Model : GP605

Ref. No. : FF-T01-K1-000016-UK1

Location : FIXING ASSEMBLY

Subject : PREVENTING DISPLACEMENT OF THE SCREW USED TO SECURE THE RECIPROCATING SHAFT BUSHING

Fig. 6

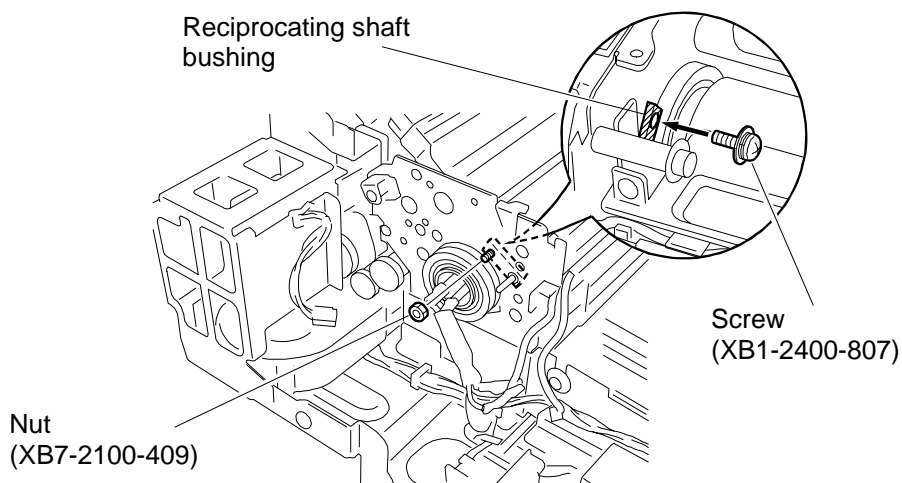
- 6) Replace the screw used to secure the reciprocating shaft bushing, and tighten the nut. (Figure 6)
- **Replace the screw used to secure the reciprocating shaft bushing with an 8mm-long screw (XB1-2400-807), and tighten it lightly so that there is no play in the bushing.**
- **With a screwdriver fitted to the screw, attach the nut (XB7-2100-409) to the screw; then, tighten it. At this time, keep the screw still using the screwdriver.**
